**Project**      **IEEE 802.16 Broadband Wireless Access Working Group** <<http://ieee802.org/16>>

**Title**          **SA-TEK Procedure Optimization during HO**

**Re:**              IEEE P802.16e/D9

**Purpose**            Adoption of proposed changes into P802.16e/D9

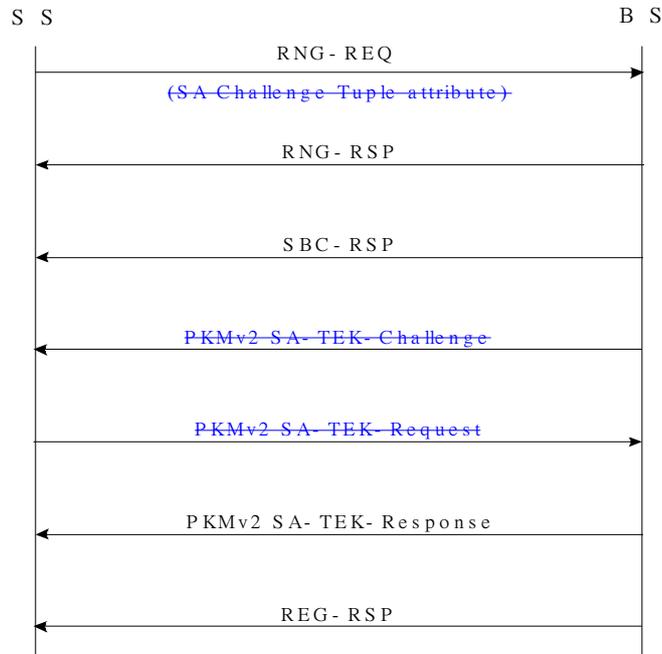
In case of omitting the authorization procedure, it is more reasonable that a target BS transmits negotiated cryptographic suite, updated SAIDs, and updated TEK through a PKMv2 SA-TEK-Response message to an MS than exchanging 3-way SA-TEK-related messages. Therefore, a PKMv2 SA-TEK-Request message and a PKMv2 SA-TEK-Response message are unnecessary during HO. The SA-Challenge tuple attribute included in the RNG-RSP message is also unnecessary.

The following figure shows the flow diagram, in case of optimizing Handover process (i.e., the case of omitting SBC-REQ, REG-REQ, and authorization procedure.) It is more efficient to skip PKMv2 SA-TEK-Challenge and PKMv2 SA-TEK-Request messages and to use only PKMv2 SA-TEK-Response message.

Only in case of omitting the authorization procedure, it is more reasonable that a target BS transmits negotiated cryptographic suite, updated SAIDs, and updated TEK through a PKMv2 SA-TEK-Response message to an MS. Therefore, a PKMv2 SA-TEK-Request message and a PKMv2 SA-TEK-Response message are unnecessary during HO. The SA-Challenge tuple attribute
